Southern Joint Regional Planning Panel
Planning Panels Secretariat
GPO Box 39
SYDNEY NSW 2001

RA15/1000
Multistorey Carpark Worrigeer/Berry Streets Nowra

Shoalhaven City Council as applicant for RA15/1000 addresses the JRPP's reasons for deferral dated 22.11.2016 with the submission of revised documentation including a Landscape plan, Architectural plans and a supporting Arborists report. The recommendations provided by the JRPP are listed below and briefly addressed:

Figure 4: 3D Visualisation of Height and Setback Controls including Exceedance

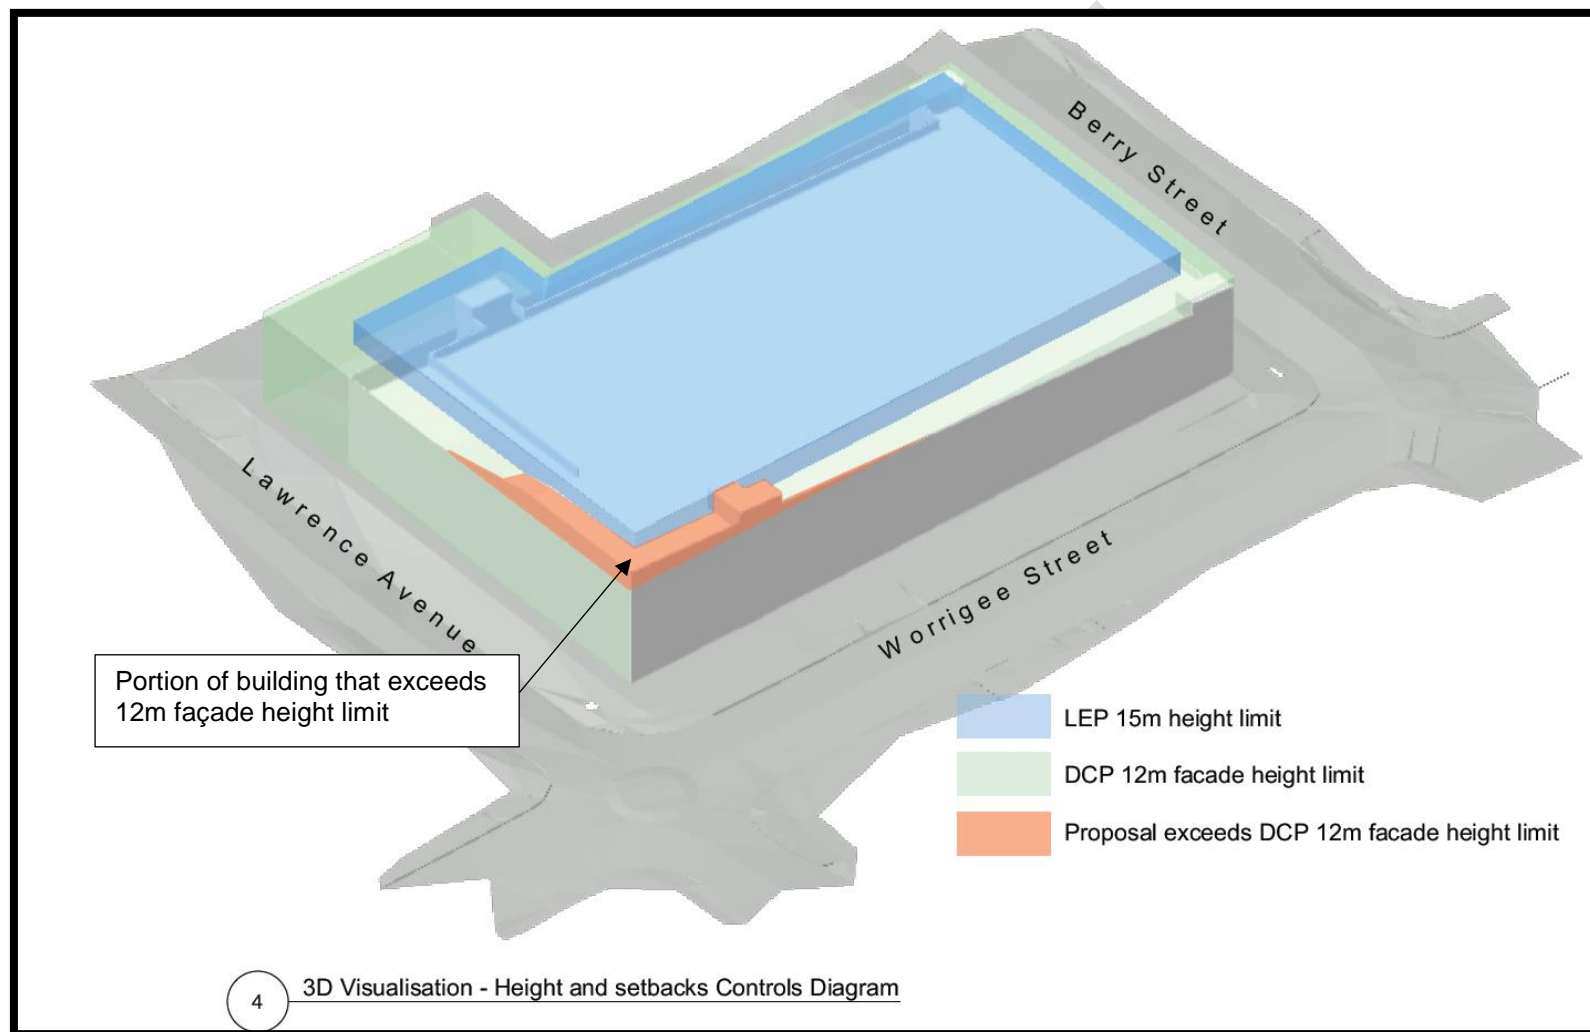
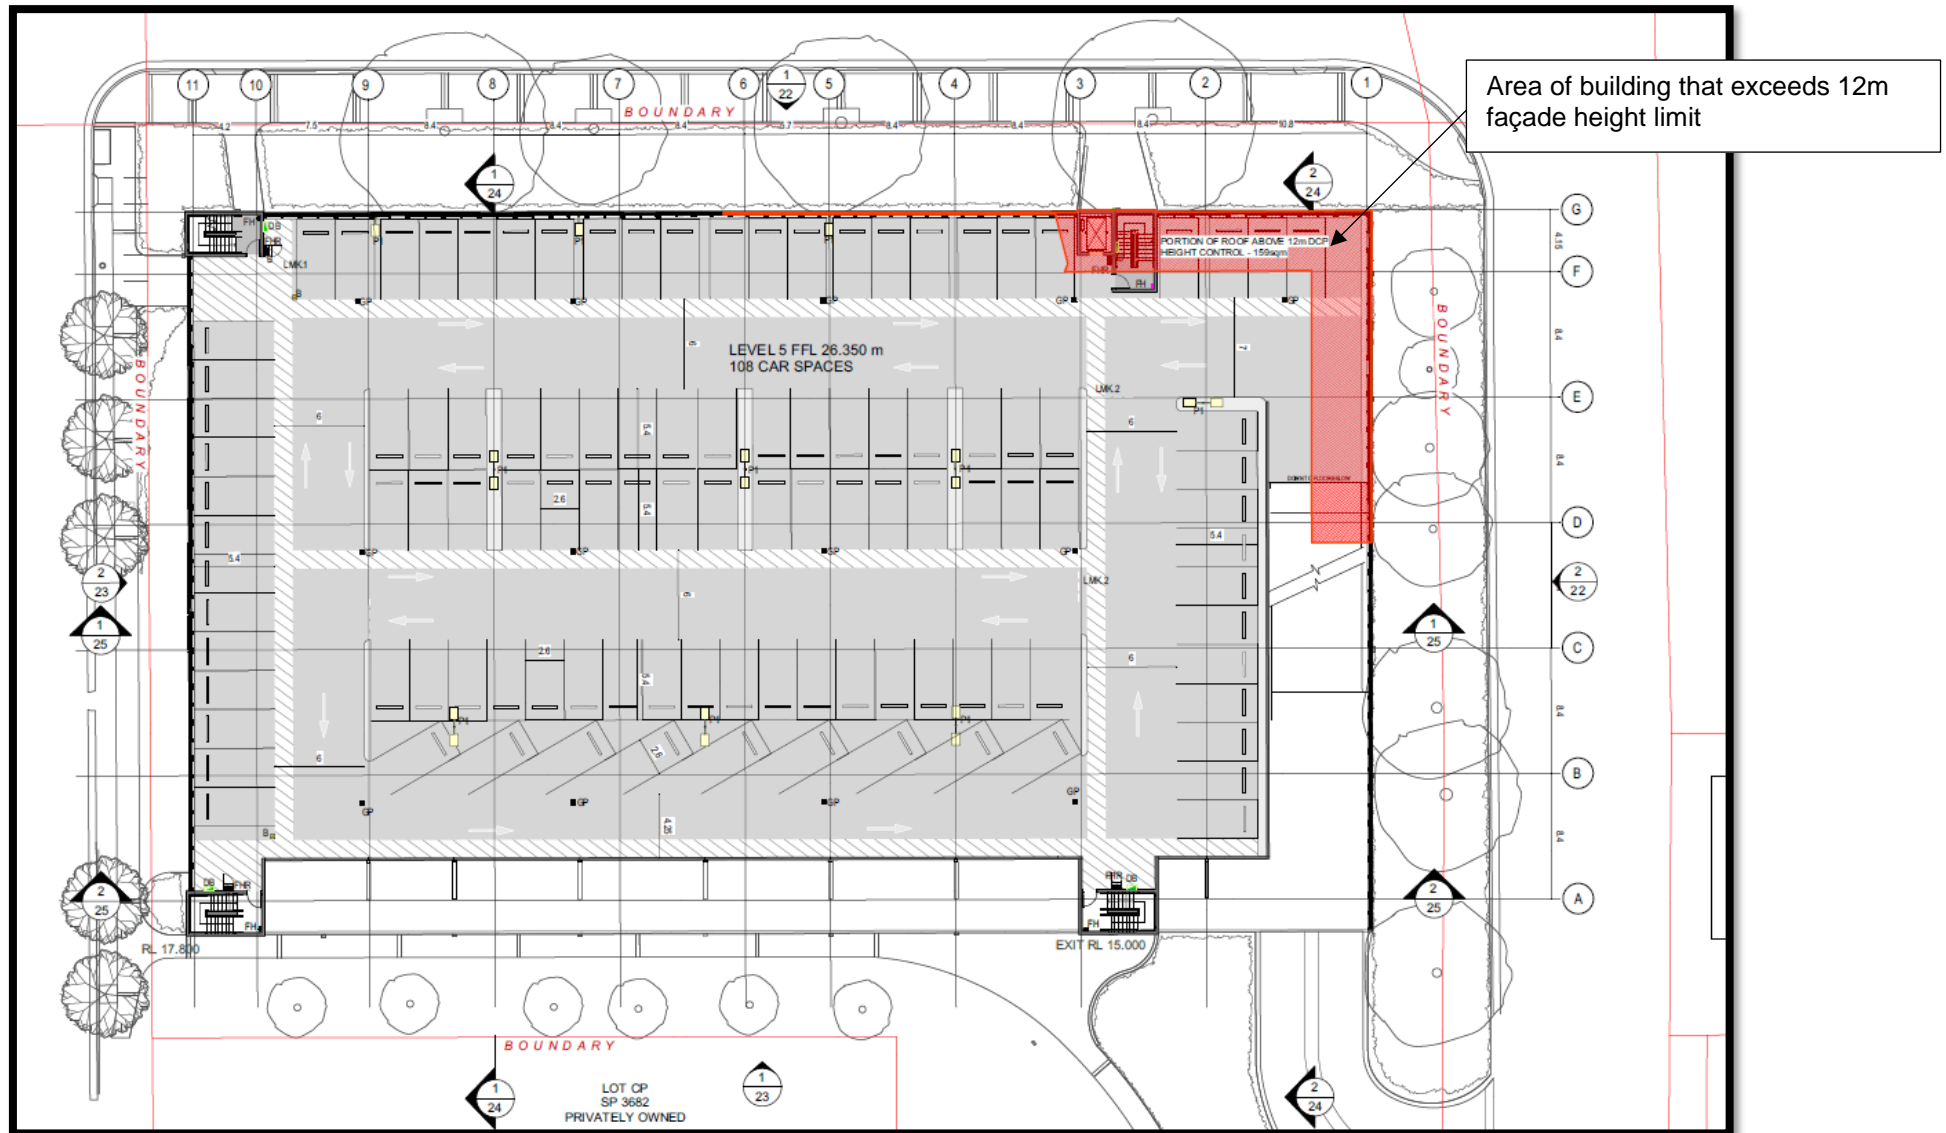
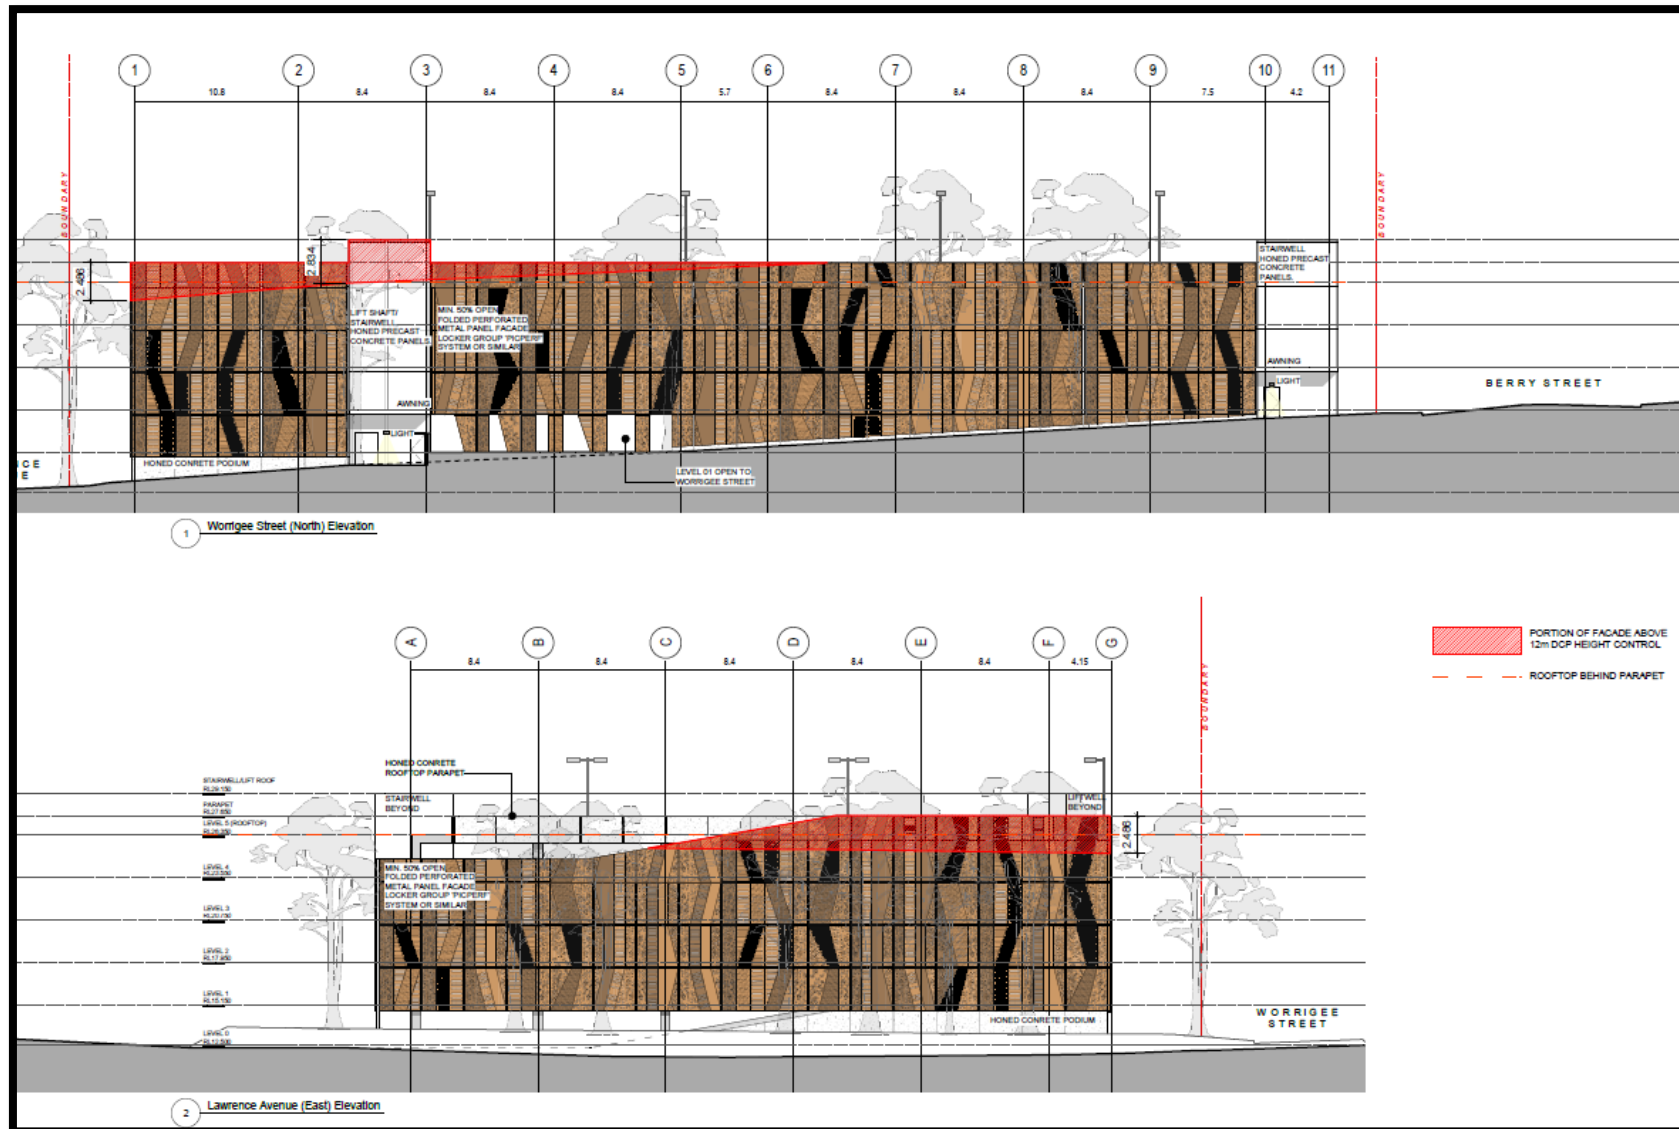
The amended proposal generally complies with the above Acceptable Solutions. The exception however is the north eastern corner of the amended proposal where one stairwell / lift shaft and a small proportion of parapet wall will exceed the 12-metre height limit that applies to the building façade height limit.

The extent to which the amended proposal exceeds this height limit is shown diagrammatically in **Figures 4 - 6** below.

As evident from **Figures 4 to 6**, and most notably in **Figure 6**, due to the topography of the site, and the fall in levels to the north-east corner of the site, the extent to which the amended proposal encroaches the 12 m recedes the further from the north-east corner.

- PLAN REFERENCE -
1311_23

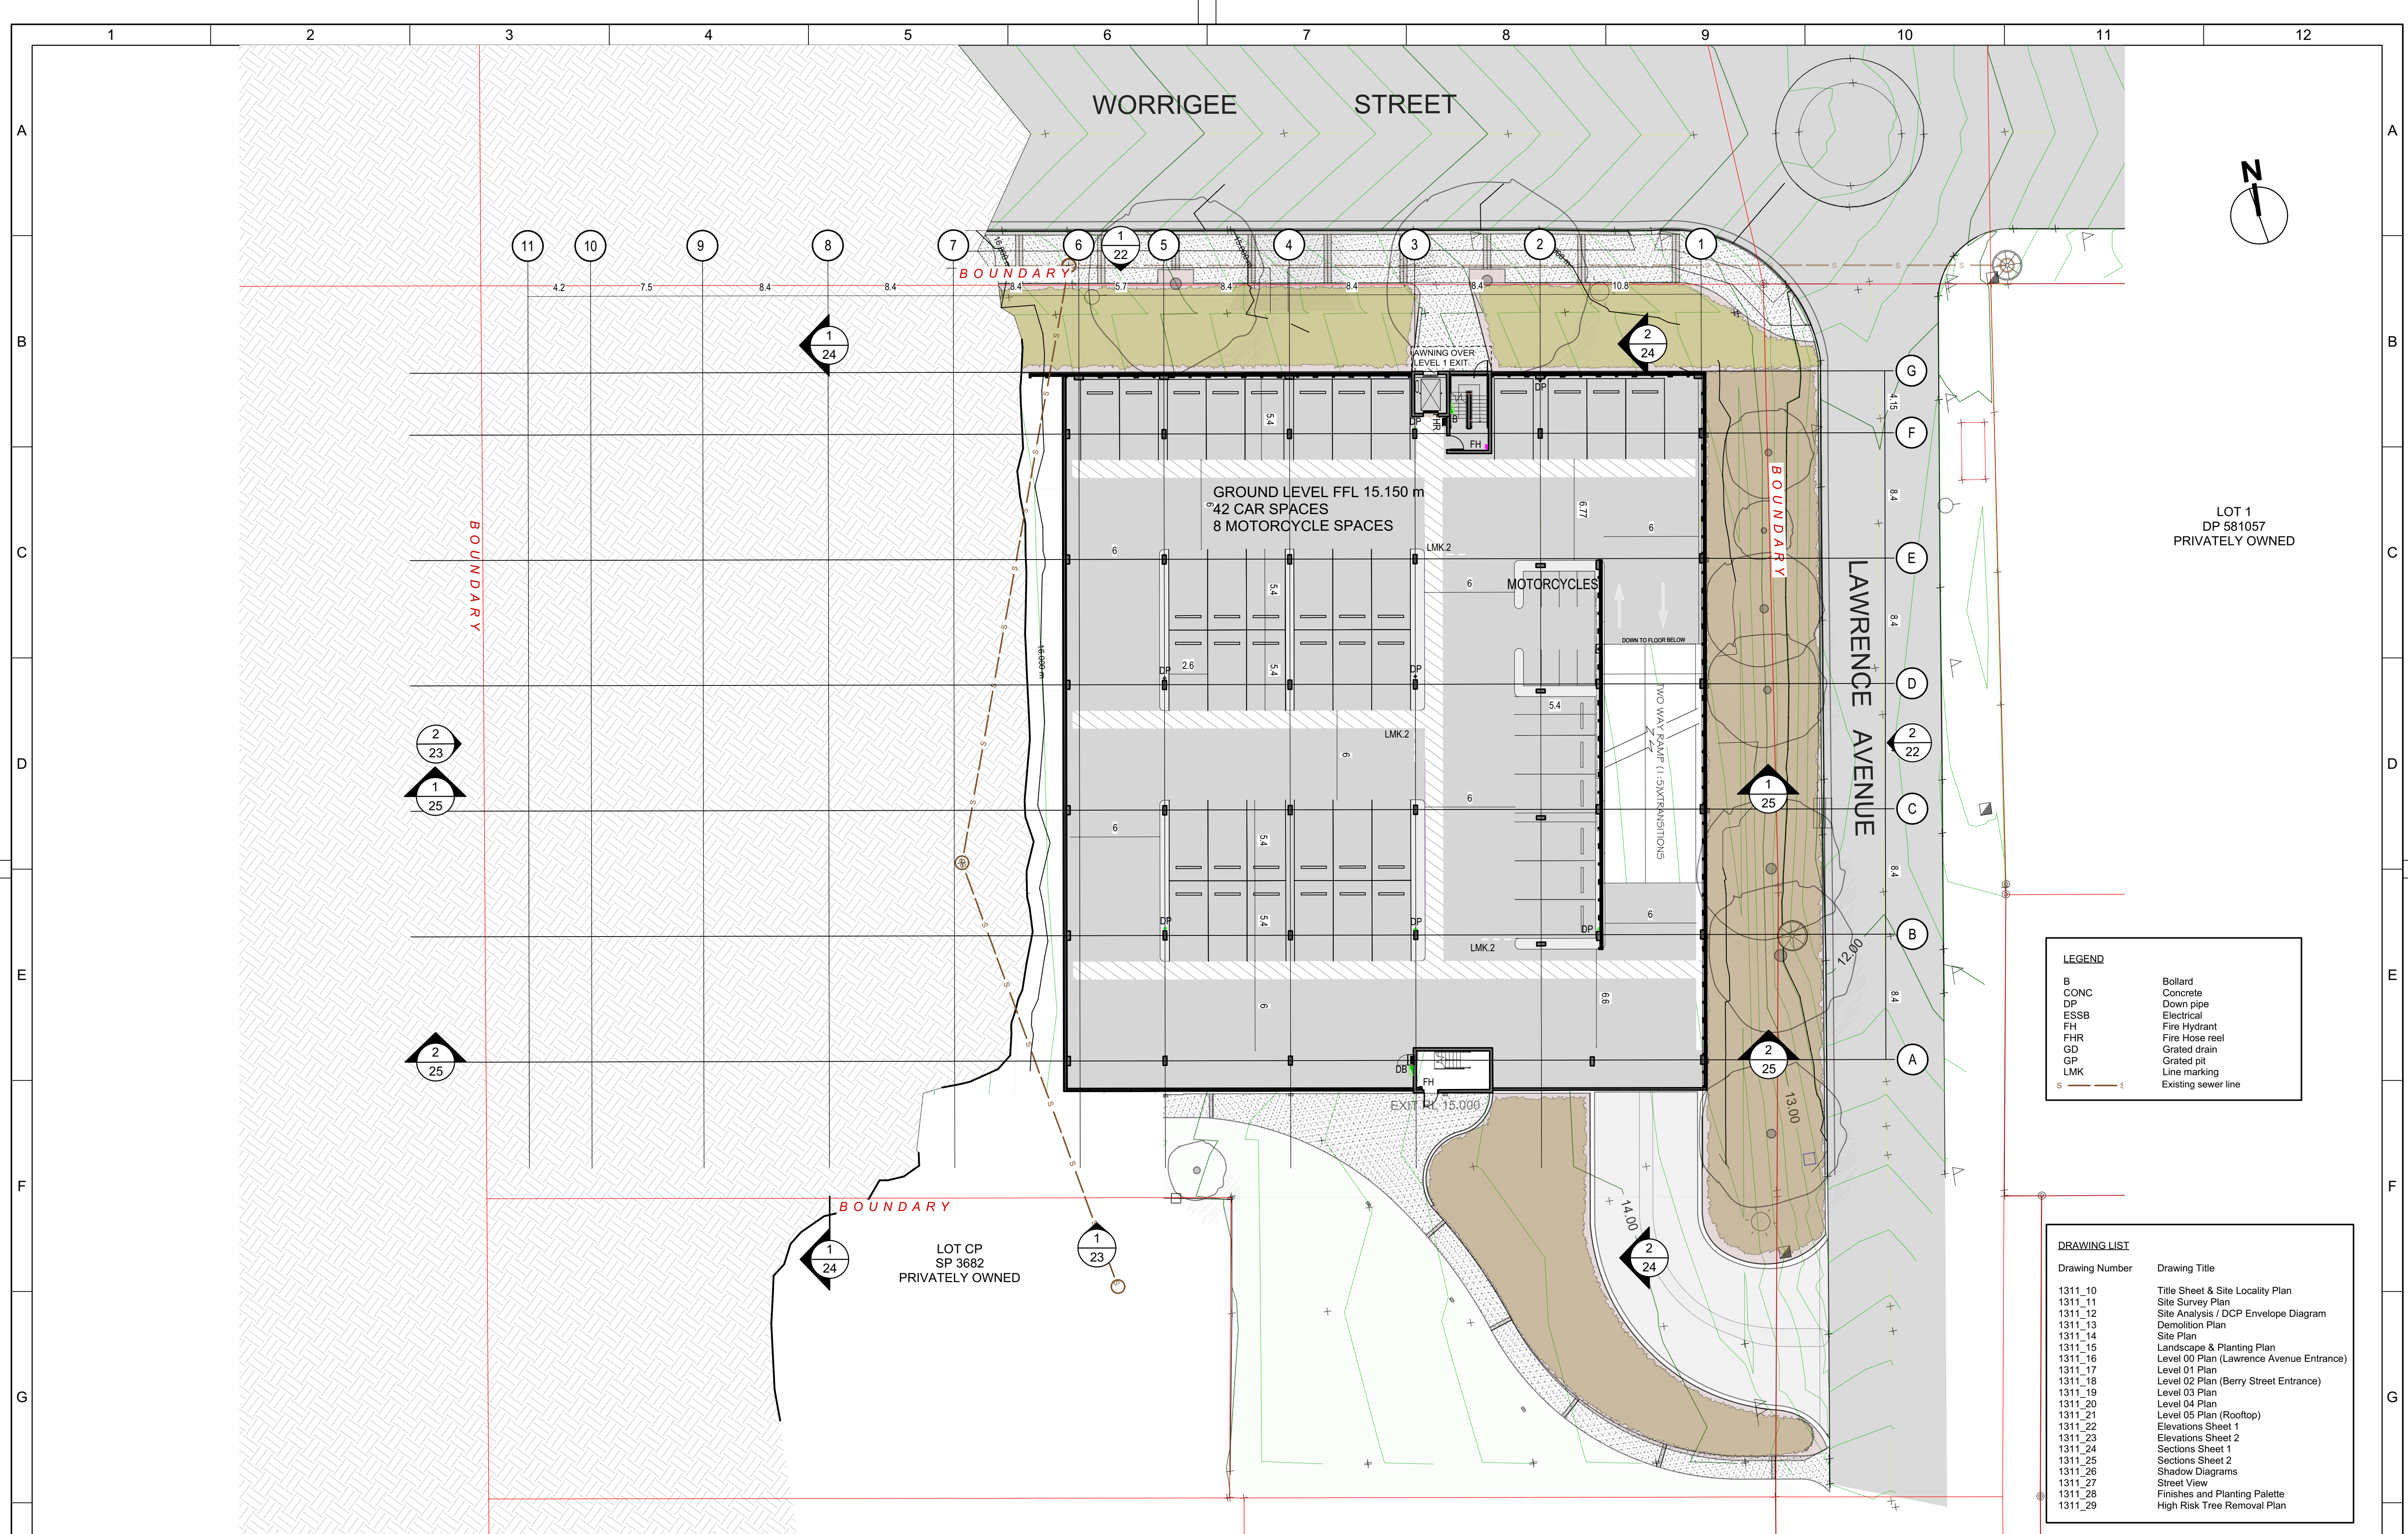
3. *An elevation treatment to the southern elevation that incorporates a more appropriate architectural solution.*

A large format mural by a professional artist is proposed to the southern face of the carpark as shown on submitted drawing 1311_23. It is further proposed that consultation on design of the mural is to be undertaken with the residents and owners of Berry Court prior to engaging a mural artist. To ensure privacy for

residents of Berry Court and to ensure adequate protection from noise, nuisance lighting and fumes, the southern façade is of solid construction.
